## **ADDENDUM #2**

### **Rye City School District**

***Issued: 2021-02-05***

**This Addendum No. 2 forms part of the Contract Documents and modifies the original bidding documents dated, January 19, 2021.**

SEAL & SIGNATURE | DATE: 01/19/21  
PROJECT No: 9200  
DRAWING BY: Author  
CHK BY: Checker  
DWG No: A2-203

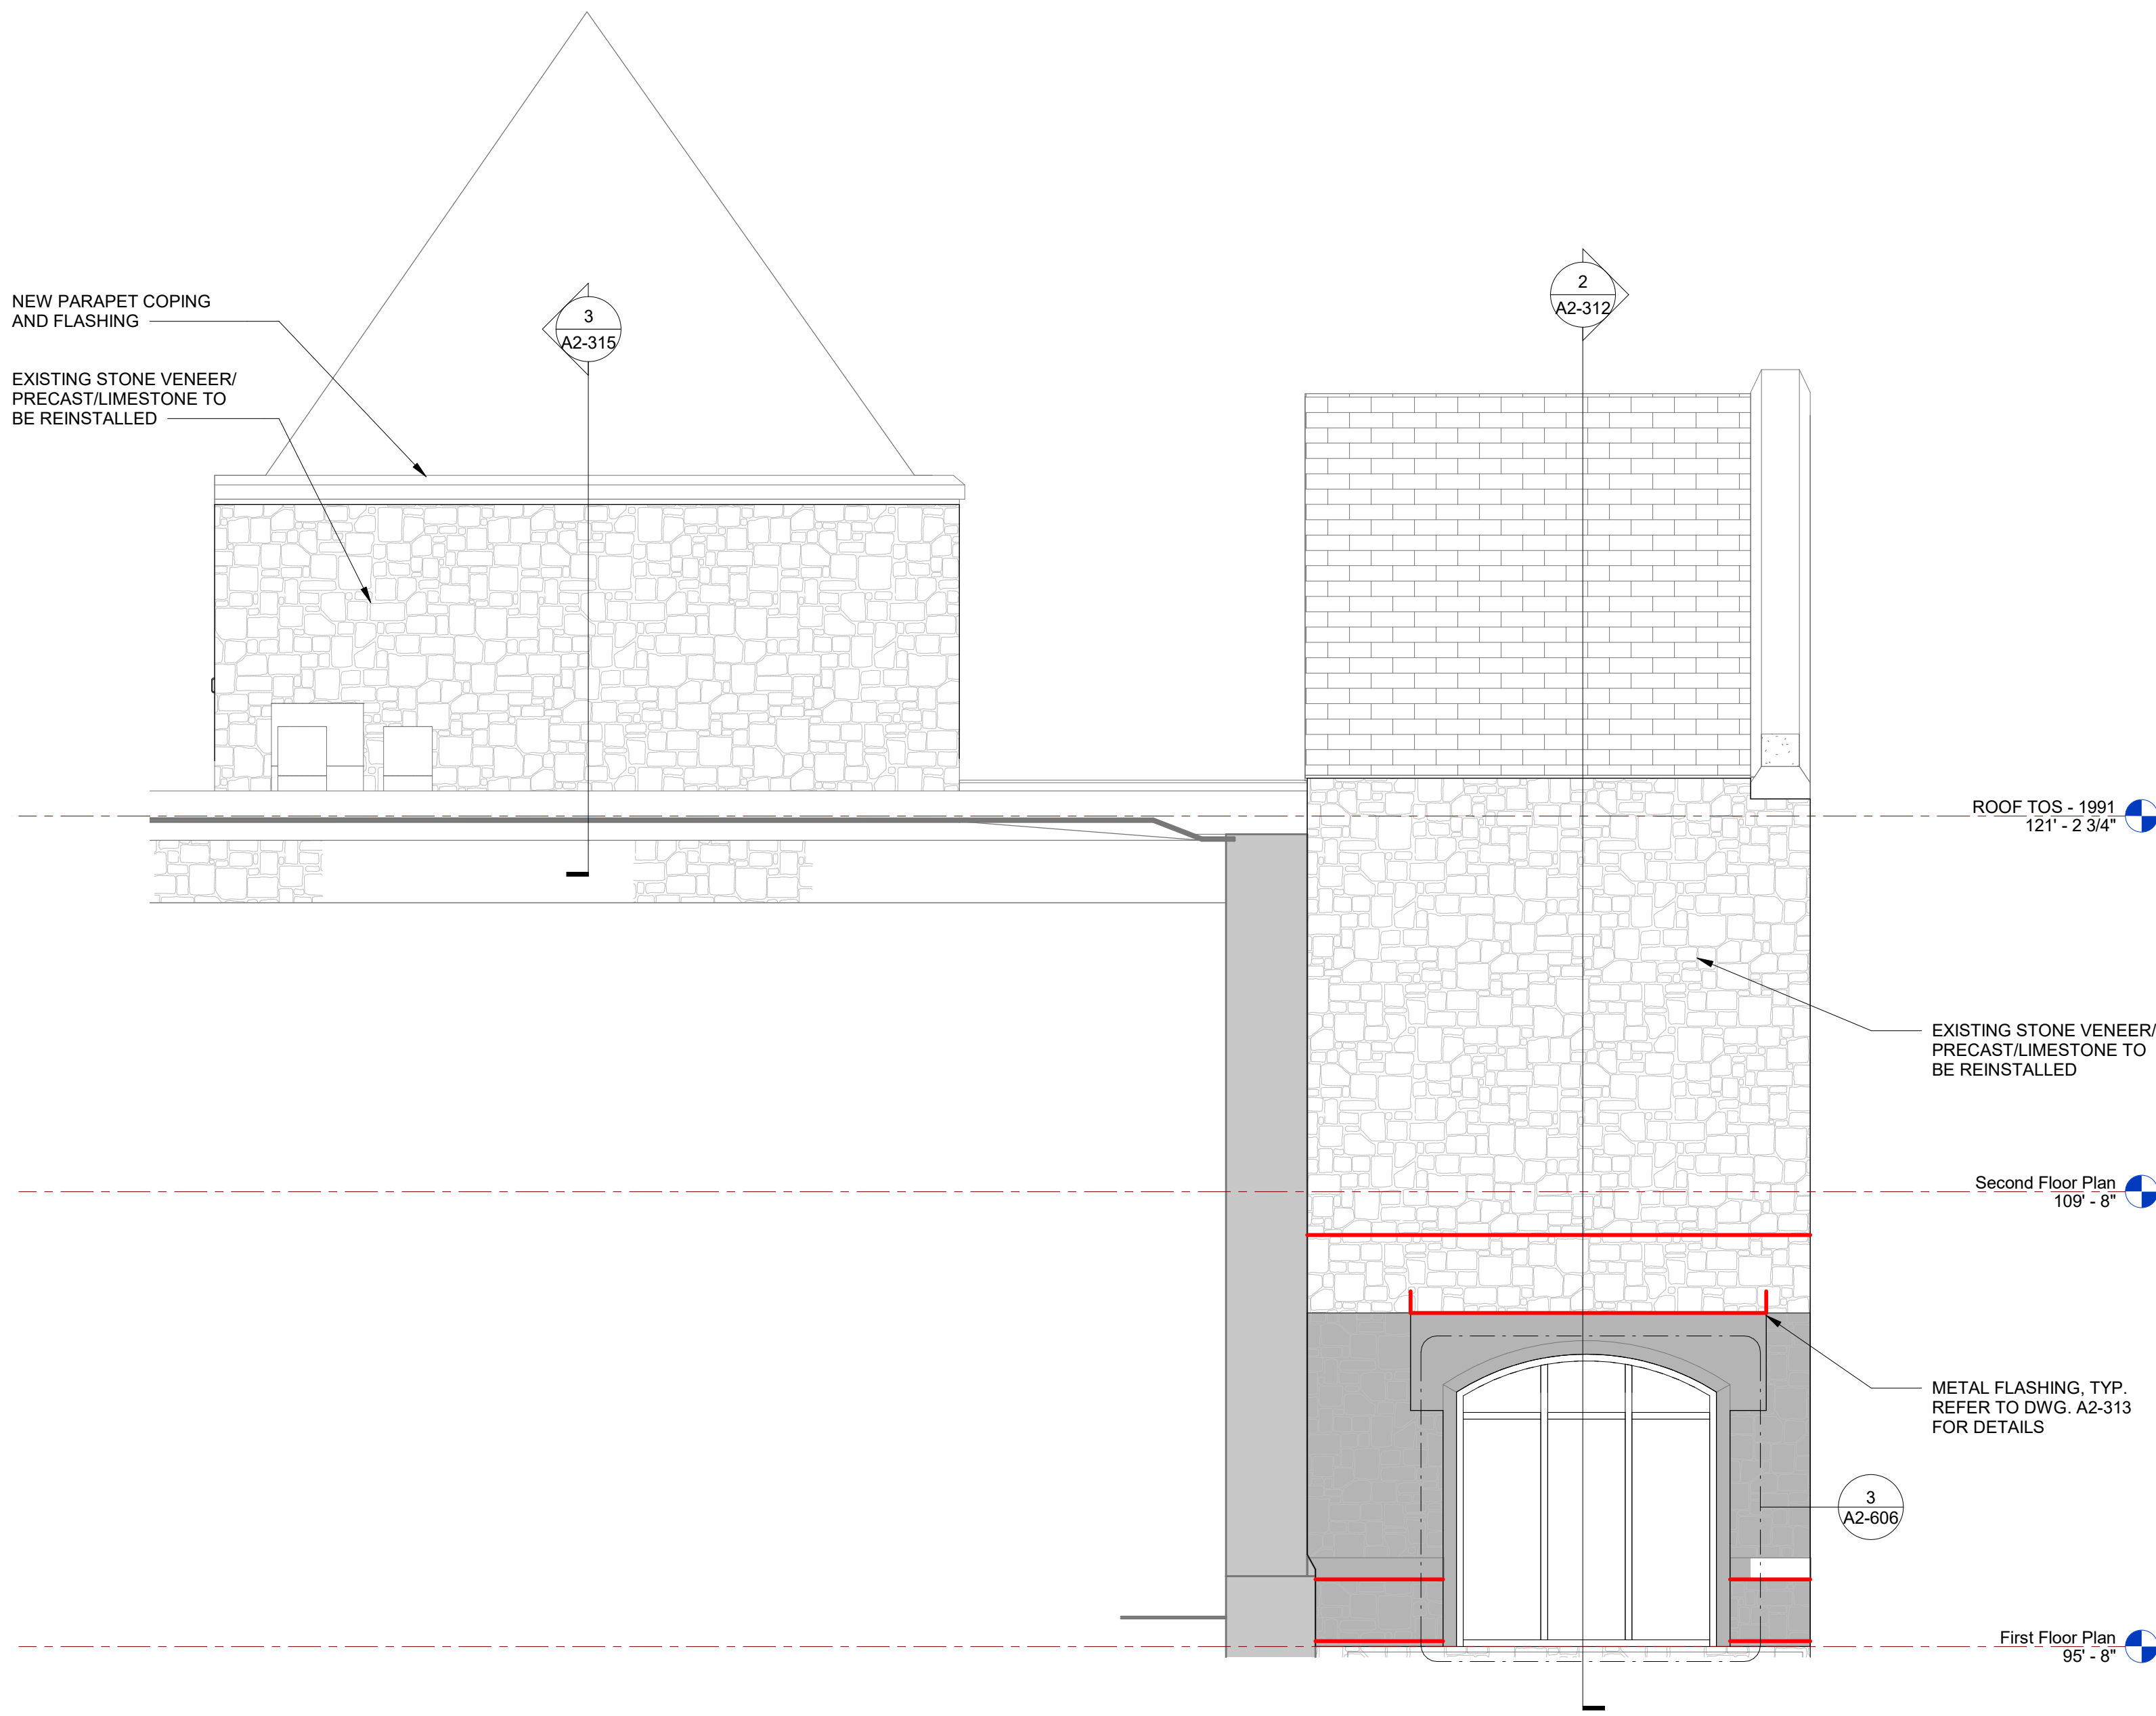
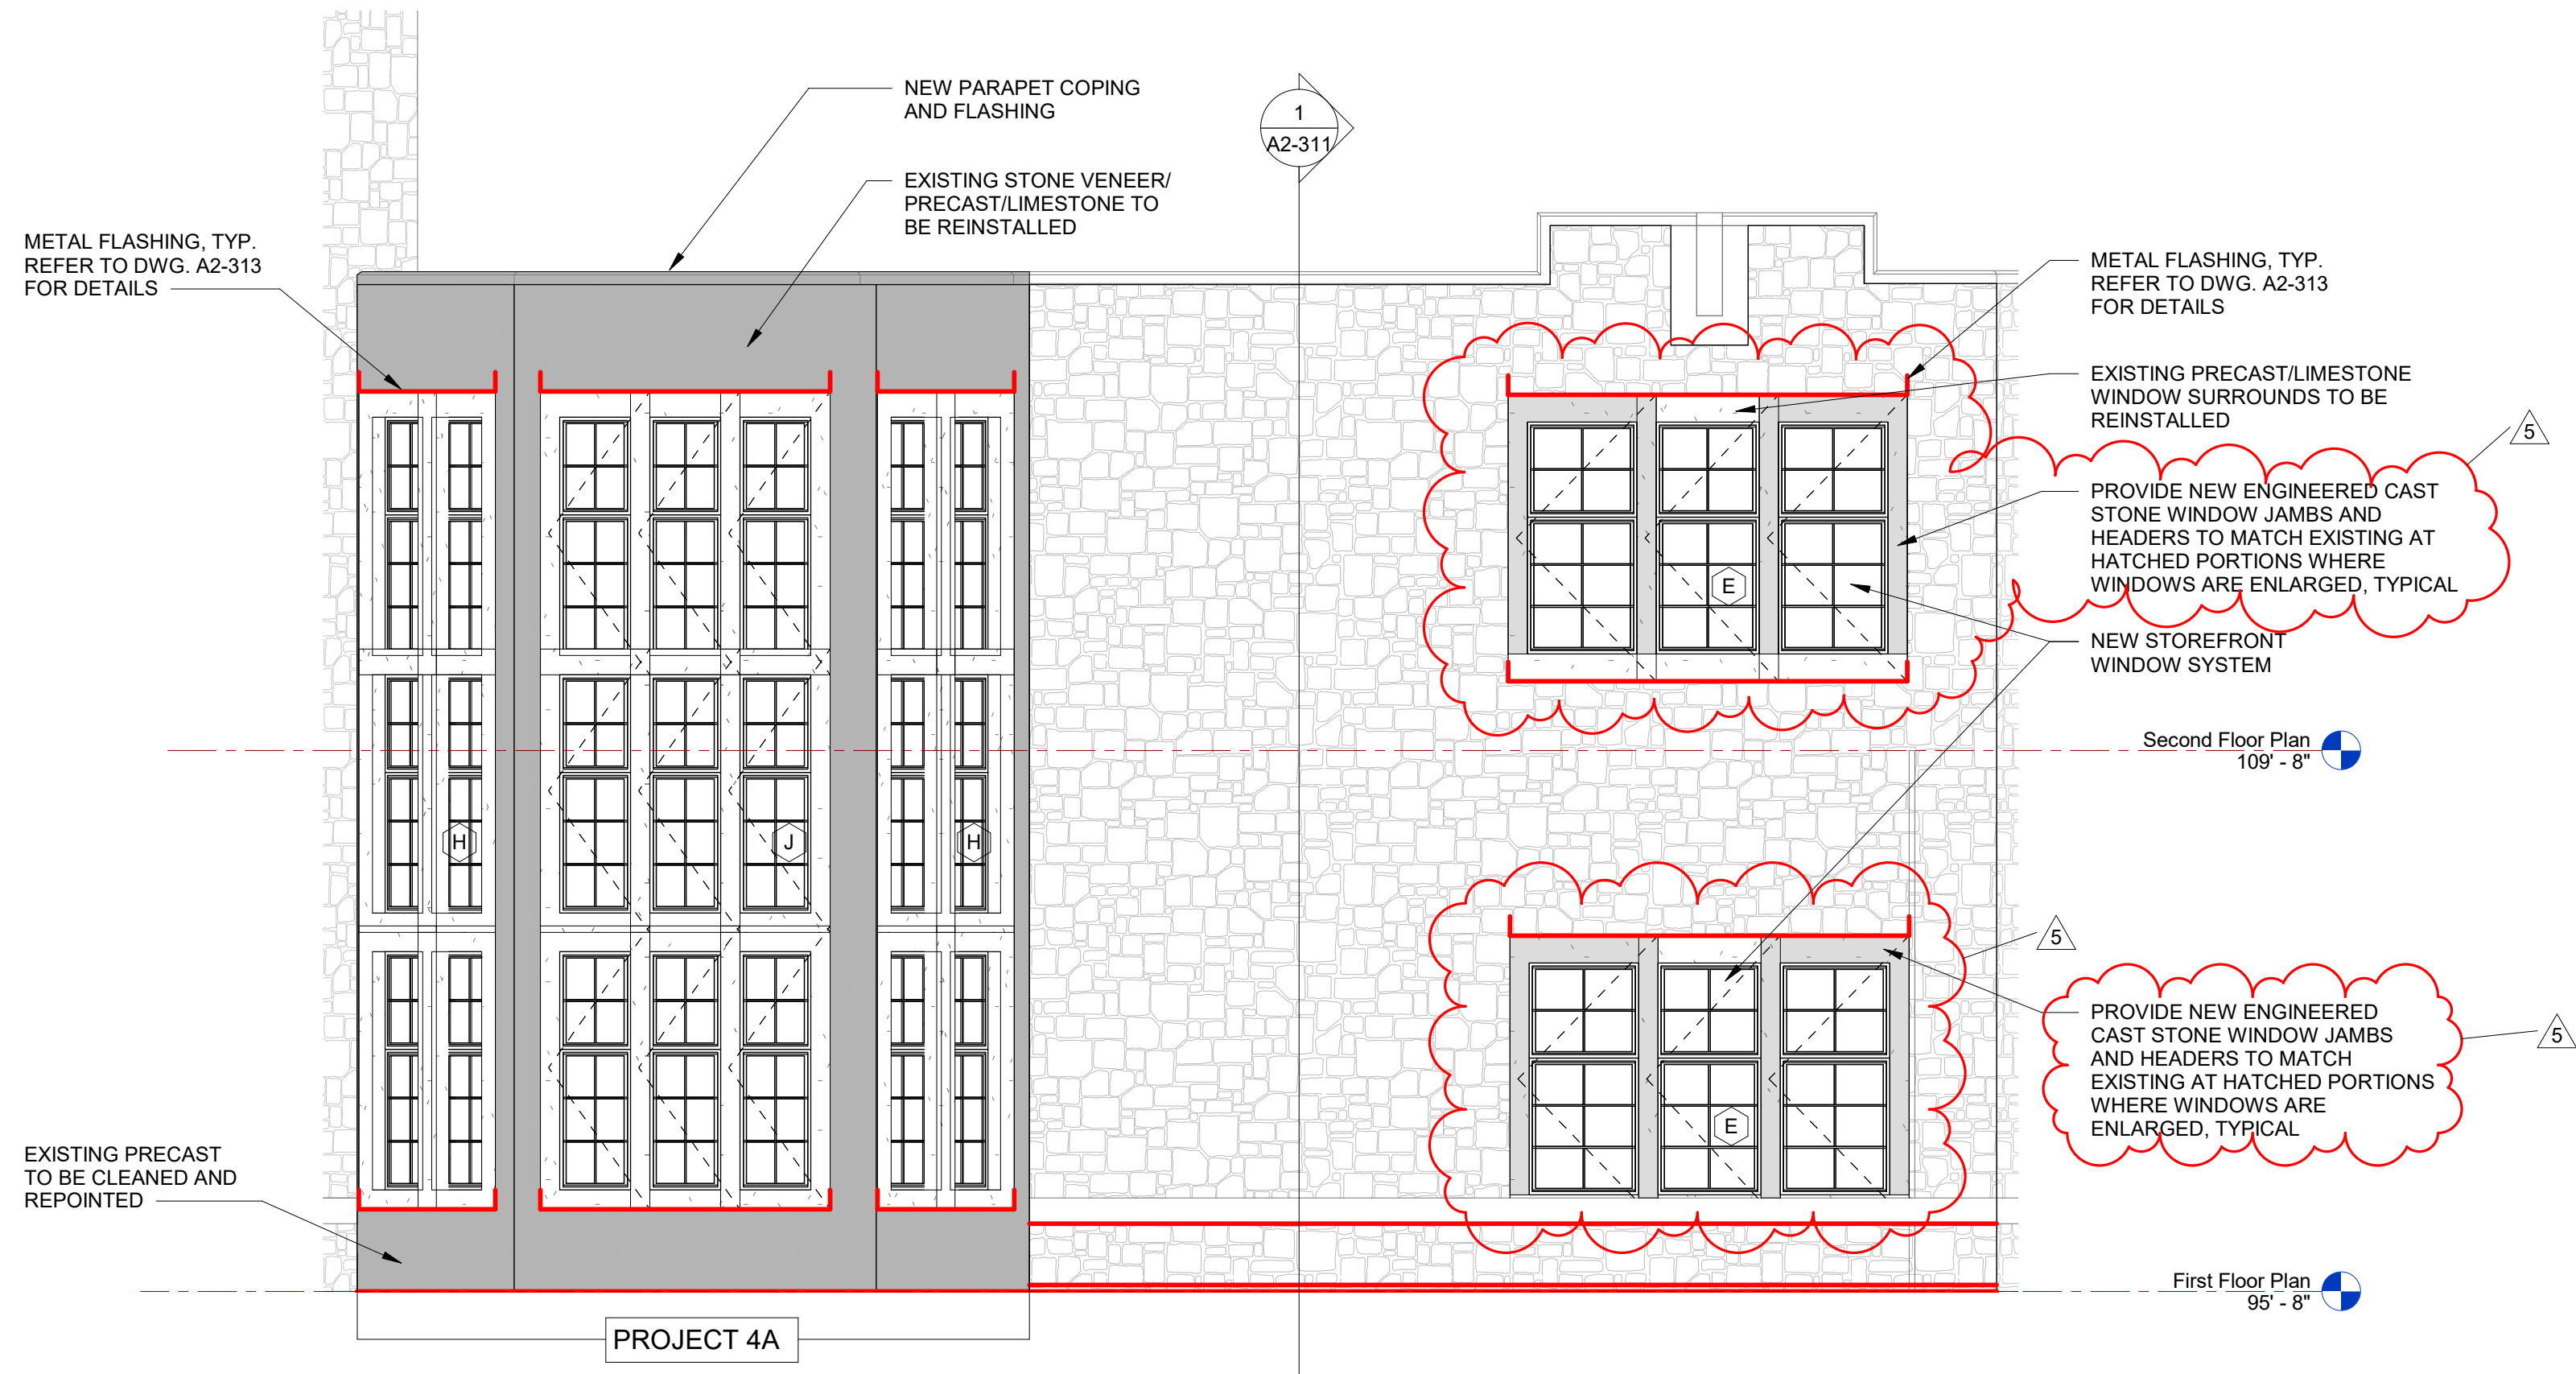
9. A2-203
  - a. Locations for new engineered cast stone window jambs and headers to match existing provided.
  - b. Elevation 2/A2-203 added.
  - c. Drawing numbers modified.

SEAL & SIGNATURE DATE: 01/19/21  
PROJECT No: 9200  
DRAWING BY: Author  
CHK BY: Checker  
DWG No: A2-350

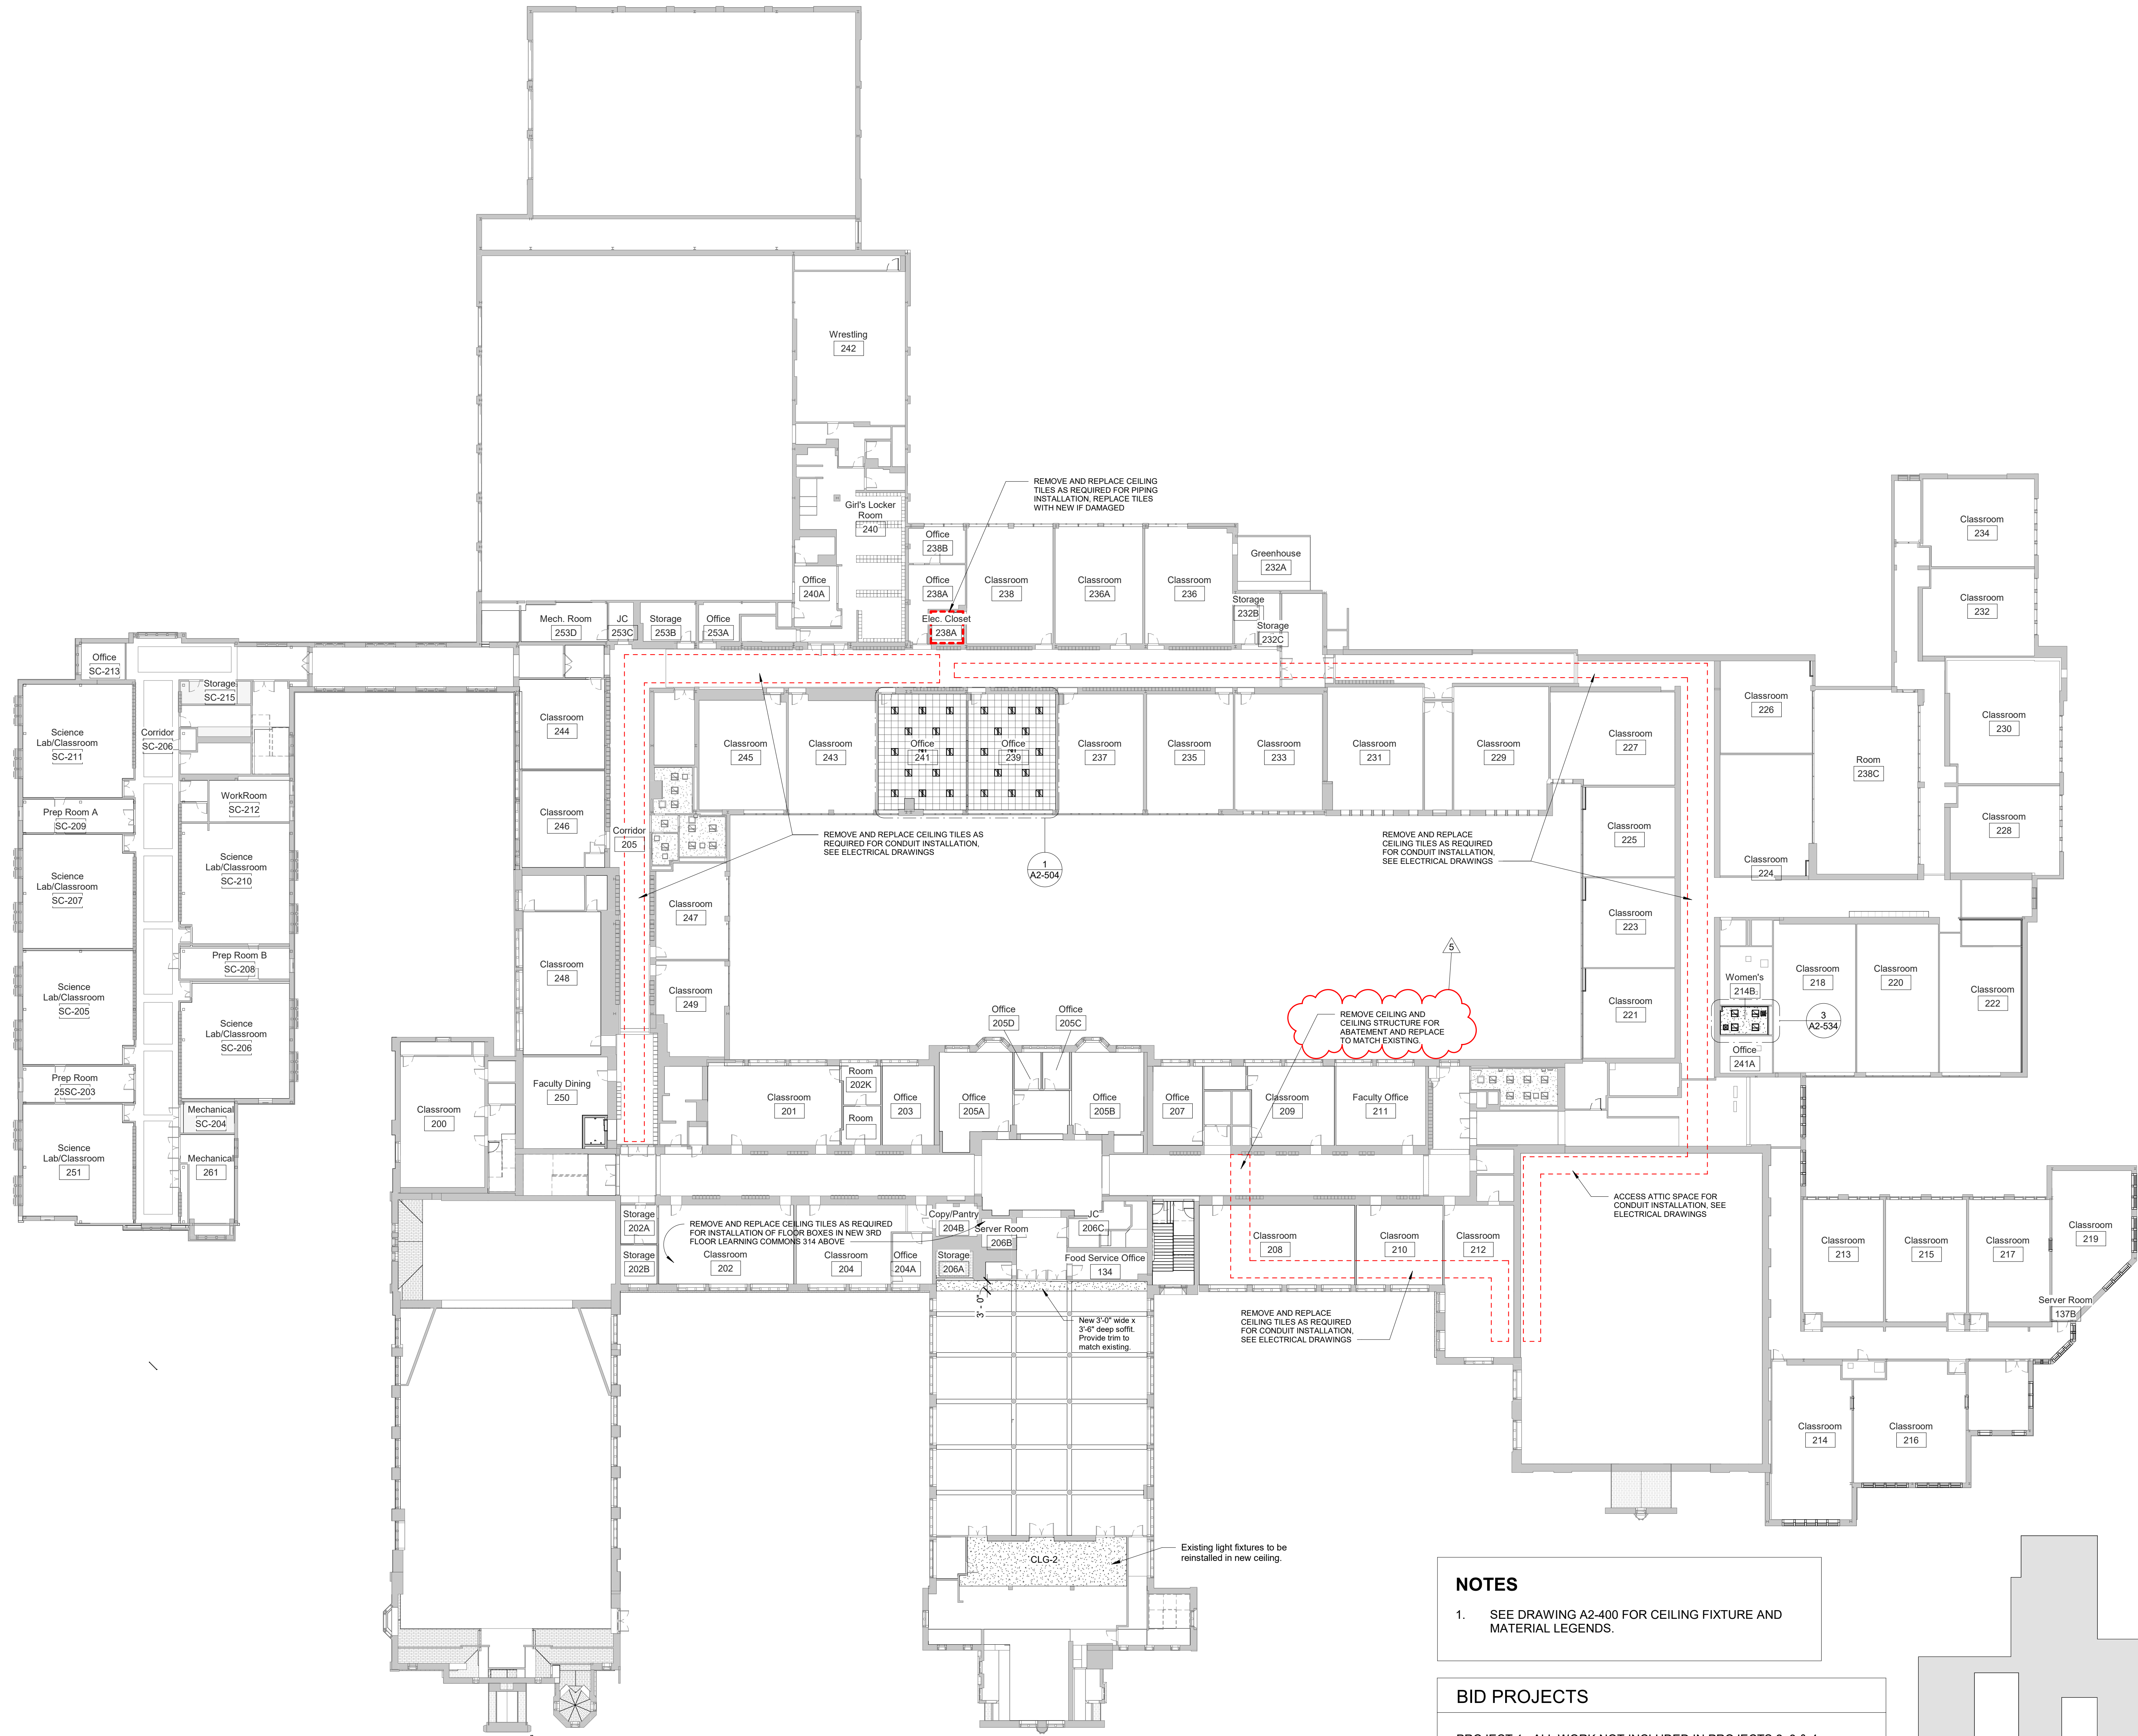
- a. Project numbers updated.
13. A2-314
  - a. Project numbers updated.
14. A2-315
  - a. Rake and eave detail updated.
  - b. Project number updated.
15. A2-350

- a. Detail #4 – Wall finish note provided.
  - b. Detail #5 – Wall finish note provided.
  - c. Detail #7 – Roof Areas provided to coordinate with roof drawings.
